UNITED STATES PATENT AND TRADEMARK OFFICE

APPLICATION NO.	FILING DATE	FIRST NAMED INVENTOR	ATTORNEY DOCKET NO.	CONFIRMATION NO.
10/626,759	07/21/2003	Koichi Ono	03-485	1731

Office Action Summary

DETAILED ACTION

FIG. 28

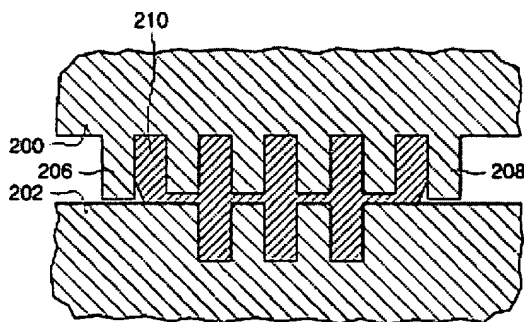
Vaganov teaches microstructures formed by planar members (wafers) bonded together by various means (including adhesive bonding). "The bonding material fills the cavities in the microstructures... In some cases the bonded surfaces include spacers which define a precisely defined distance between the two wafers, thus providing an exactly specified thickness of the bonding material "(Abstract). As shown in Figure 28 below, the upper plate / 'lid' 200 covers the lower plate 202 which has a central recessed portion between two gaps 'formed between the plate member and the lid member'.

FIG. 31

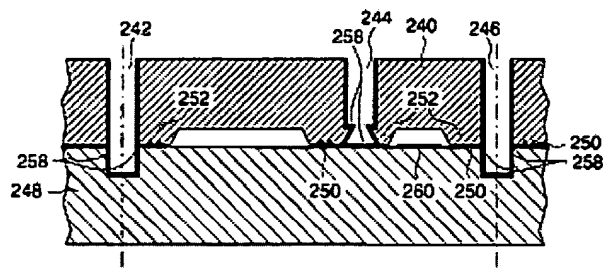
With respect to claims 4 and 6, Vaganov discloses, as illustrated in Figure 31, holes 242 and 246 formed in the cover for introducing adhesives.

FIG. 4A

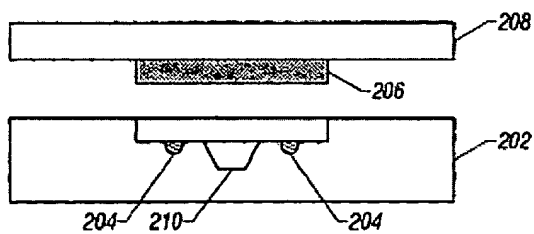
Zhao discloses micro-fluidic devices of various structures for conducting electrophoresis. As shown in Figure 4A, substrate 202 comprises channel 210 ['recessed area' – Ex.] and grooves 204 ['gaps' – Ex.]. The substrate is bonded to the lid 208 with adhesives (See [0092], [0089]).

FIG. 2

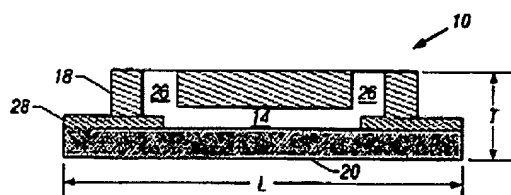
Figure 2 illustrates holes in the lid communicating with the recessed area.

FIG. 44A

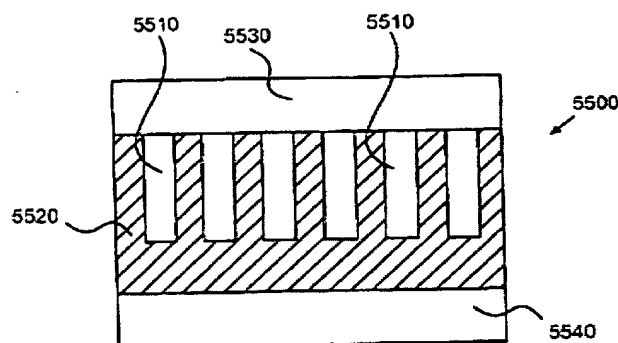
adhesives. One of the embodiments shown in Figures 44A, 44 B comprises a cartridge / plate 5520 having a plurality of chambers ['recesses' and 'gaps' – Ex.] 5510 and a coverslip 5530 having inlet and outlet holes 5532 and 5534 communicating with the chambers. –(See [-342], [0152]).
